SUBJECT: Responds to 871111 request for mod of info re ATWS
 Mitigation Sys Actuation Circuitry plant-specific design
 concerning Generic Ltr 83-28. Implementation package to be
 provided by end of May 1988.

Donald C. Cook Nuclear Plant Units 1 and 2
Docket Nos. 50-315 and 50-316
License Nos. DPR-58 and DPR-74
GENERIC LETTER 83-28 ANTICIPATED TRANSIENT WITHOUT
SCRAM (ATWS) MITIGATION SYSTEMS ACTUATION CIRCUITRY
(AMSAC) ADDITIONAL INFORMATION

Attachment 1 to AEP:NRC:0838AD

AMSAC LOGIC DIAGRAM

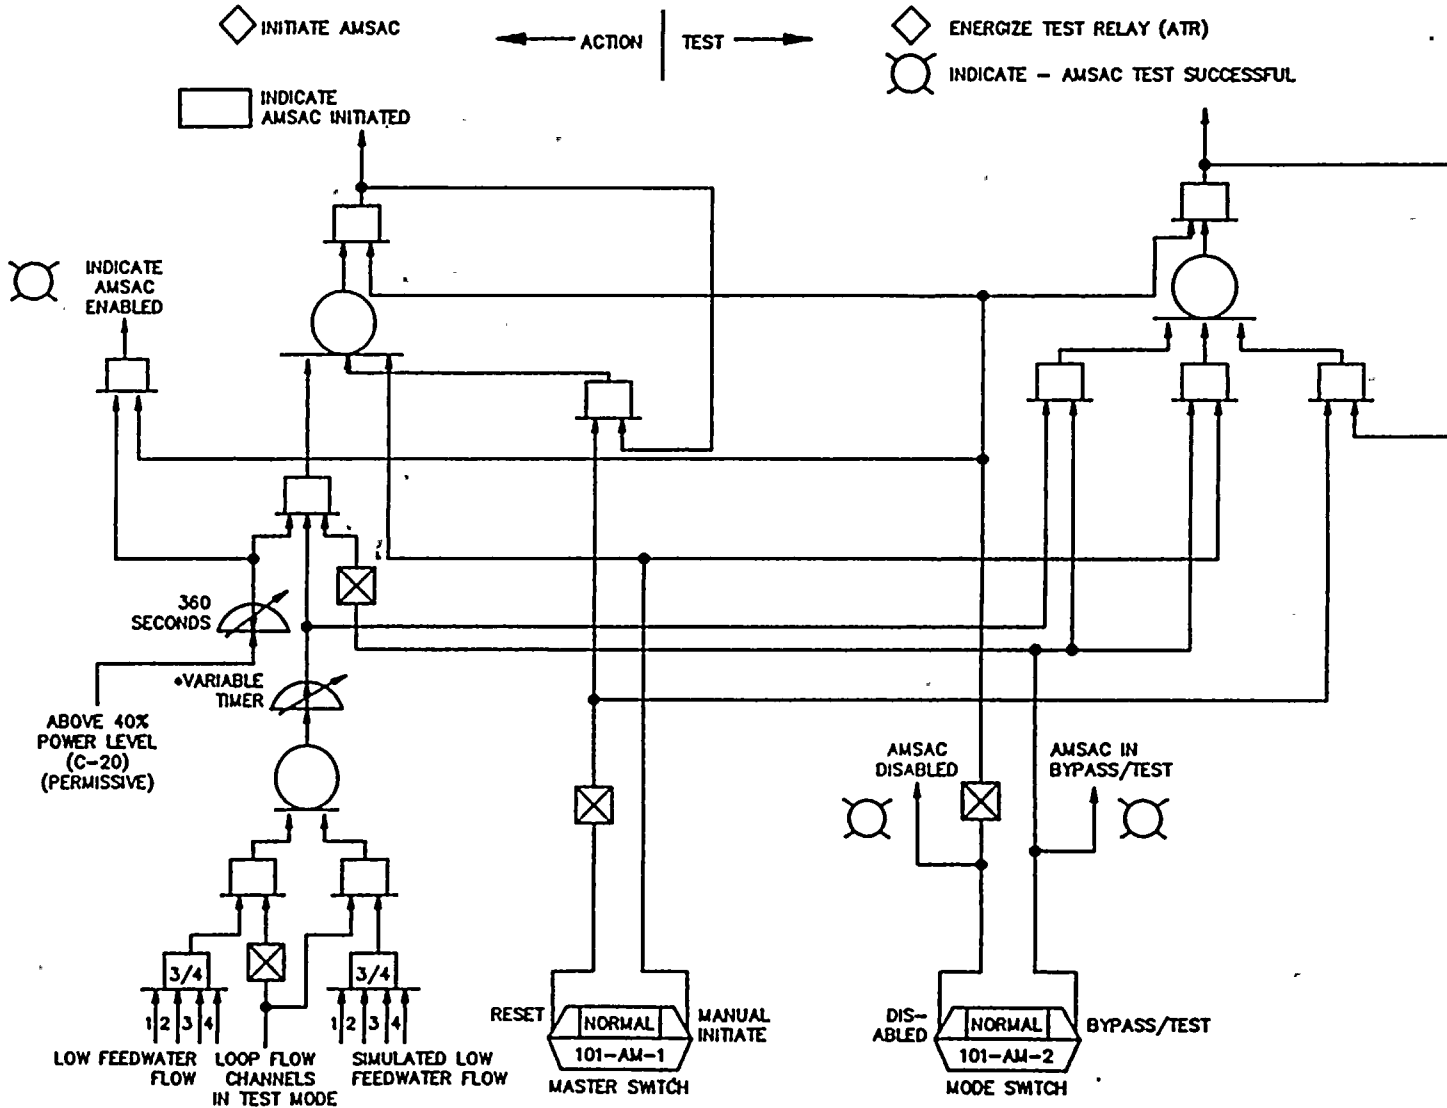
Attachment 2 contains our logic diagram for the AMSAC. Originally we had envisioned using four control switches. As a result of our human factors review, we will be using only two control switches as shown on the diagram. We believe the two switches contain the same capability as the four switch configuration and some consolidation is achieved.

FIGURE 3-8: AMSAC VARIABLE TIME DELAY

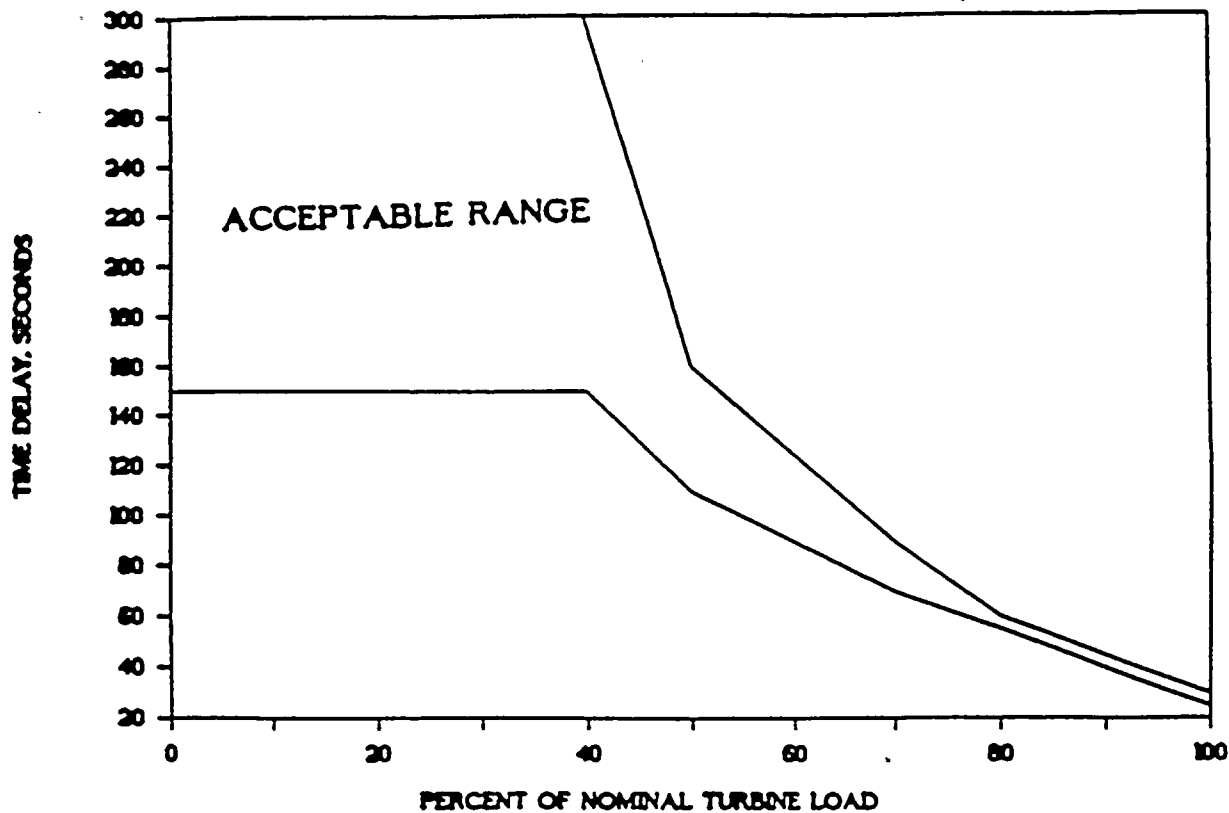
The variable timer performance characteristic will be within the Westinghouse-specified acceptable limits. Attachment 3 is a graph showing initiation timer delay vs. power level, which was published by Westinghouse.

AMSAC CONTROL SWITCHES IN THE CONTROL ROOM DTU PANEL

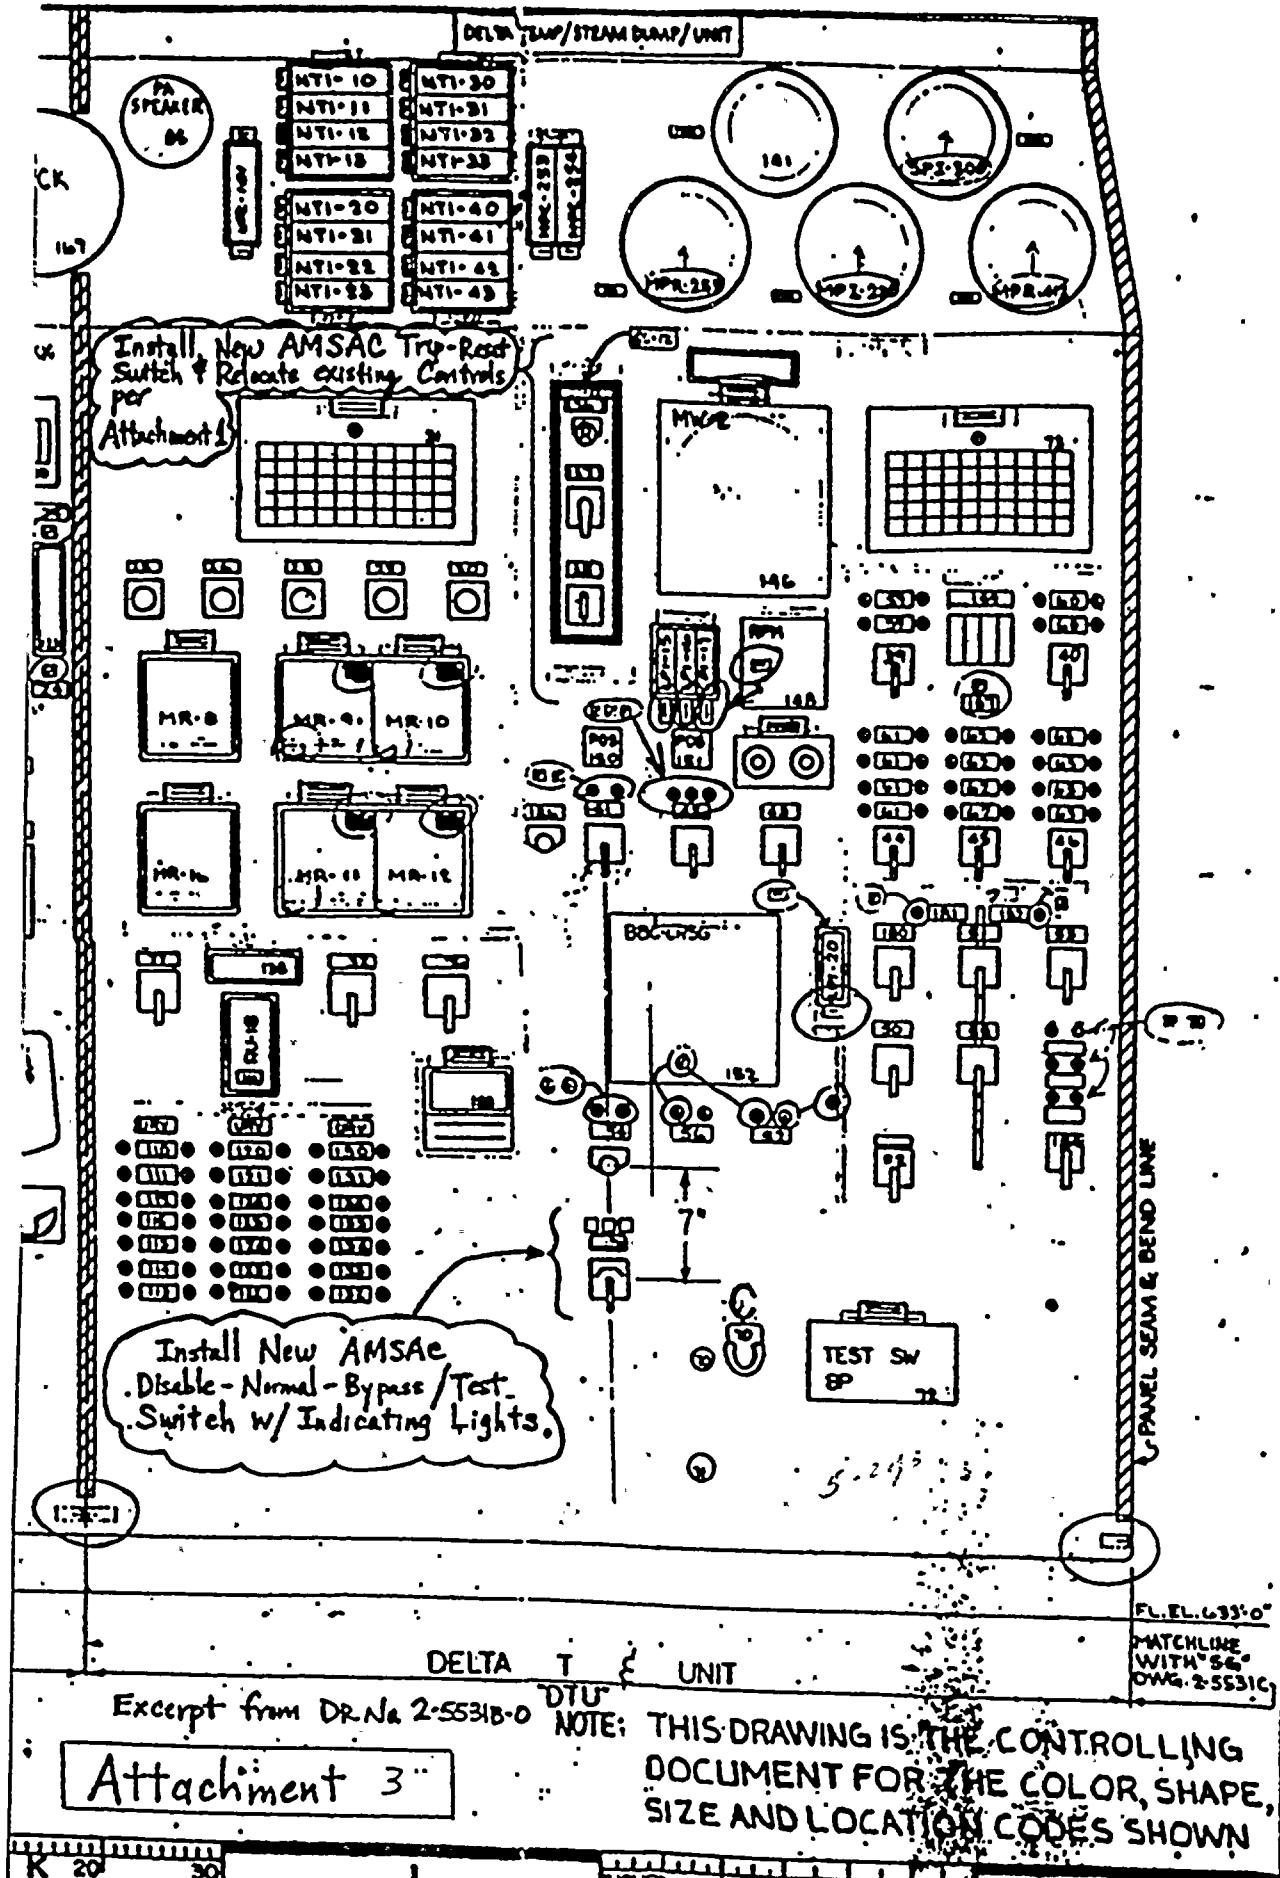
AMSAC will be disabled for repair and maintenance. This will be accomplished through a bypass switch whose status will be continuously displayed in the control room. We have completed a human factors review and Attachment 5 contains the figure showing the future switch locations and configurations which are consistent with the results of the review. The switch will be used by plant operators, and plant procedures will be written to incorporate proper operating and maintenance sequences.

Manual initiation of AMSAC at the system level will be accomplished through a control switch. Please see Attachment 5 for the switch configurations and locations which resulted from our Human Factors Review.

Install New AMSAC Trip-Reset Switch & Relocate existing Controls per Attachment 1

Install New AMSAC Disable-Normal-Bypass/Test Switch w/ Indicating Lights.

Suggested AMSAG Trip Reset Control Switch Location on DTU Panel

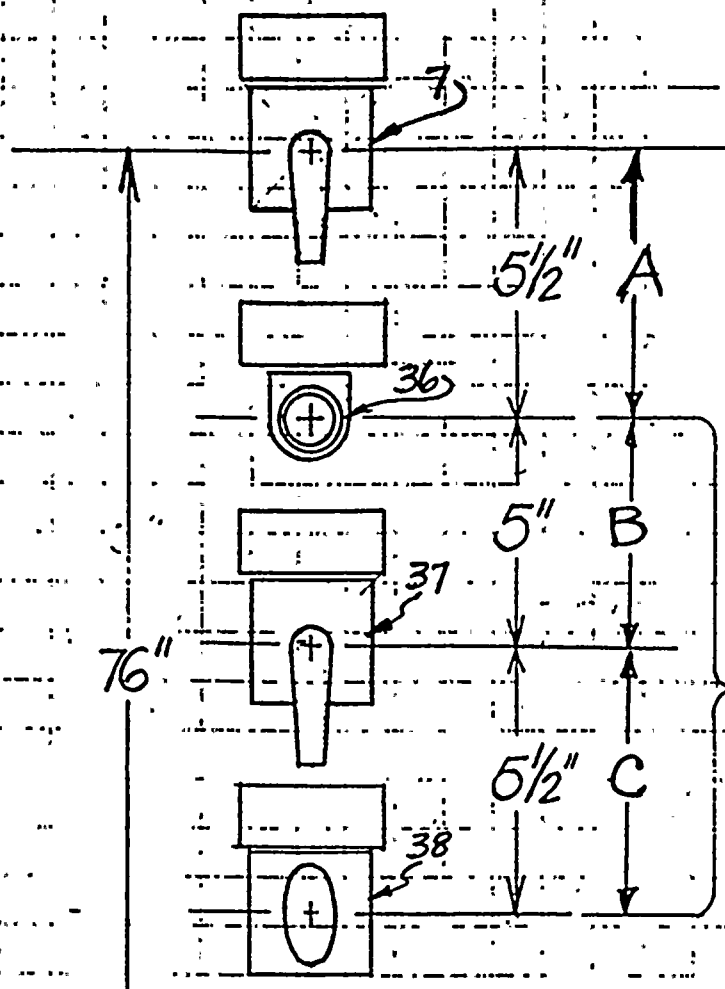
Note: Spacings between controls less than standard, but satisfactory since no indicating lamps with switches and space restrictions are acute.

Have EGS verify above dimensions physically possible

Install New
AMSAG
Trip-Reset SW

Relocate Main Turbine
Vacuum Breaker Trip
Solenoid Trip
Turbine Reset
Controls
